Access Compliance Report

Public Rights-of-Way

Intersection ID: 14018	Main Street: BAY_ST	Cross Street: WESTOVER_ST	Location: E
ADA ID: 47E008610F14	Ramp Type: Perp	Initial Pass/Fail: Fail	Overall Compliance: No
		Severity Score: 12.5

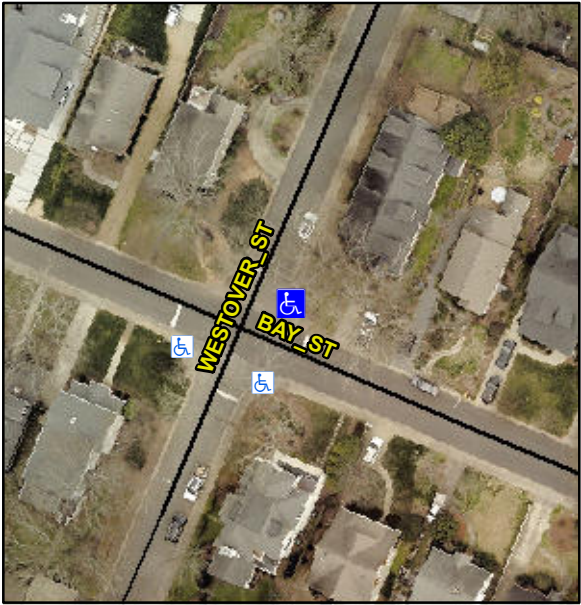
Codes/Mitigation Info/Possible Solution			Field Measurements/Component Compliance		
	Possible Solutions:		Compliance	Description	Data
	Remove & Replace Entire Ramp.		No	Ramp Length (in)	60.0
			Yes	Ramp Width (in)	54.0
			N/A	Flare Type LT	N/A
			N/A	Flare Slope LT (%)	N/A
			N/A	Flare Traversable LT?	N/A
			N/A	Landing Length (in)	N/A
			N/A	Landing Width (in)	N/A
			N/A	Landing Slope (%)	N/A
			N/A	Landing X Slope (%)	N/A
<p>Surveyor Notes:</p> <p>N/A</p> <p>PROW/ADA:</p> <p>Not Found, R304.2.2</p>			N/A	Flare Type RT	N/A
			N/A	Flare Slope RT (%)	N/A
			N/A	Flare Traversable RT?	N/A
			N/A	DWS Provided?	N/A
			N/A	DWS Contrast?	N/A
			N/A	DWS Length (in)	N/A
			N/A	DWS Full Width?	N/A
			N/A	DWS Offset (in)	N/A
			N/A	Shared Landing?	N/A
			N/A	Gutter Ponding?	Yes
<p>Street 1 Name</p> <p>Stop Condition-Street 2</p> <p>Street 2 Name</p> <p>Stop Condition-Street 1</p>			N/A	Gutter X Slope (%)	N/A
			N/A	Gutter Lip Ht (in)	N/A

No	Painted X Walk1?	N/A
			To S	X Walk 2 Direction	N/A
			N/A	X Walk 2 Width (in)	N/A
			6.3	X Walk 2 Slope (%)	N/A
			3.0	X Walk 2 X Slope (%)	N/A
			N/A	Ramp inside XWalk2?	N/A
			N/A	Clear Space?	N/A
			N/A	Clear Space to XWalk (in)	N/A
<p>Total Cost:</p> <p>\$ 1850.00</p>			N/A	Storm Grate/Utility Hazard?	N/A
			N/A	Storm Grate/Utility Type	N/A
			N/A		N/A
			Yes	Surface Condition? (G/P)	Good
